## AES/EBU Interface Causes Pops and Clicks

**Position of resistors R36 and R37 on AES/EBU Interface Board 1.864.170.00**

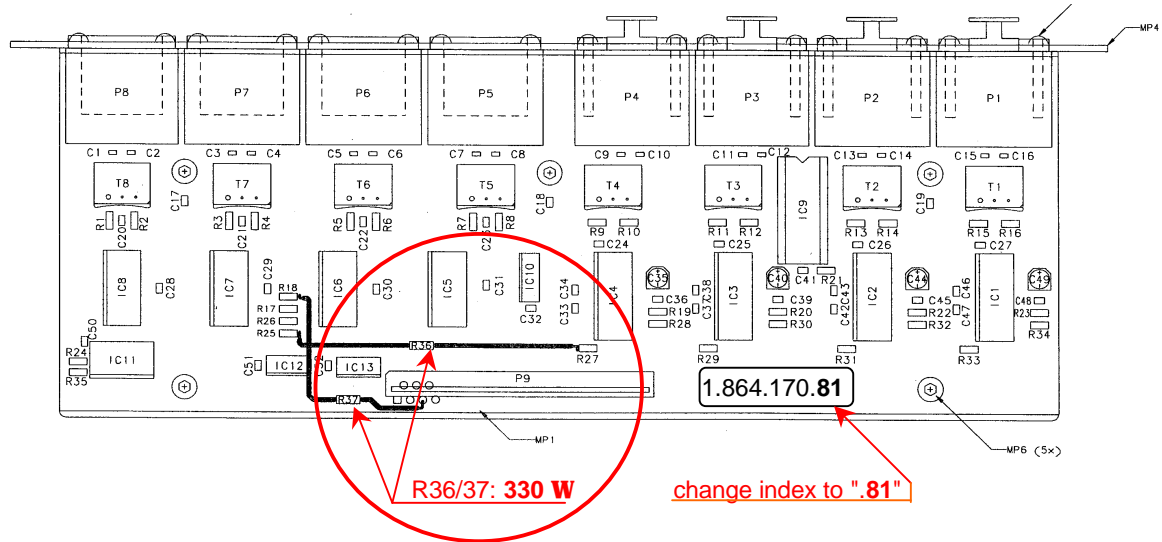
The optional AES/EBU interface 1.864.170.00 can exhibit clicks, pops or other audible noise when used in a machine configured as slave. The interface in the master machine always operates correctly. The phenomenon frequently occurs with the last unit in a chain of, say, three units linked for use as a 24-channel machine. The following procedure completely solves the problem. It is recommended that all available interfaces should be modified.

1. *Separate the unit from the mains supply.* Remove the AES/EBU interface completely. It is accessed from the top of the machine. Remove the unit's top cover (6 Allen-head screws).
2. The AES/EBU interface is now freely accessible and can be removed by unscrewing the four screws (Allen key no. 2) from the rear. Carefully unplug the flat cable on the AES/EBU interface. Both free-wired resistors R36 and R37 (1 kΩ each) must be replaced by 330 Ω (57.10.1331), which results in improved fall and rise times of the chip clock. Modify the label 1.864.170.00 to 1.864.170.81 by hand, e.g. with a permanent marker; this is important for later identification of the assembly.

**AES/EBU Interface 1.864.170.00 diagram, partial view. After modification, the assembly is called 1.864.170.81 (i.e., modification index "81").**
